Planning Committee

Update Report for the Committee

3. Requests for Deferral/Withdrawal
4. Schedule of Applications
- (a) **19/01476/AS – Newtown Railway Works, Newtown Road, Ashford, Kent, TN24 0PN** - Detailed application for a mixed-use development comprising:-

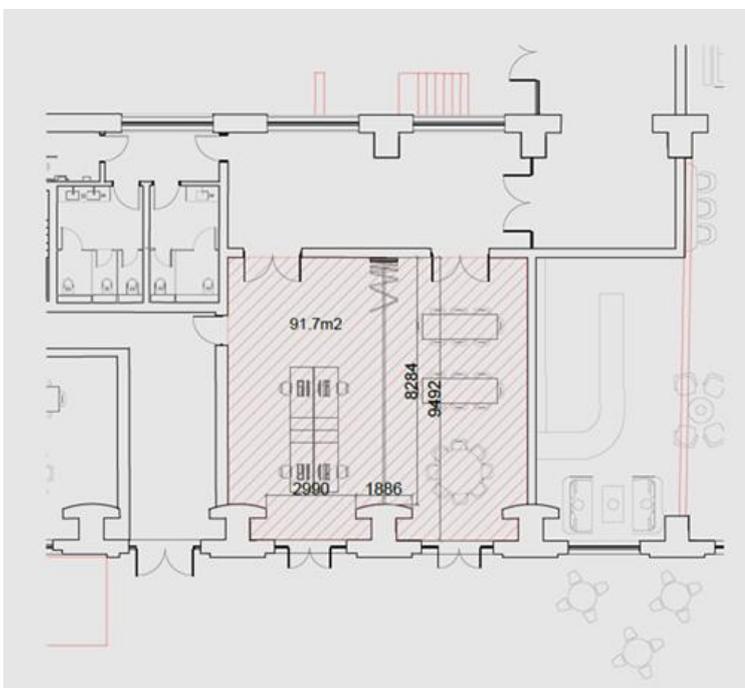
As paragraph 40 (vi) and Figure 28 of the report identifies, the applicant's proposal in the amended plans is to include a Community Room located within the ground floor of the Locomotive Shed adjacent to a proposed café. The café would be located at the junction of the commercial / educational and residential uses that are proposed within that building. The proposal provided for a 41.4 sqm room as shown circled in red on the drawing extract below;-

I understand that the applicant has since discussed this proposal at a second public consultation event and, as a consequence, has now tabled with me a revised drawing (Drawing 200.00 Rev P3) that would provide for an enlarged 91.7 sq.m room for use at certain times with flexibility to be subdivided or opened up into one large room as needs require. The applicant's agent suggest this is indicative which I take to mean that there is scope to adjust the proposition further. The enlarged room is shown hatched red on the drawing extract below;-

I support the amended proposal. It would double the amount of community use floorspace in a good location. Recommendation (B) in the report provides the ability for Drawing 200.00 Rev P3 to be substituted in place of the earlier iteration dealing with the ground floor of this part of the Locomotive Shed. SWNCC has also raised issues with me in terms of the detail of the proposed 'Community Use Agreement' to be secured by s.106 planning obligation.
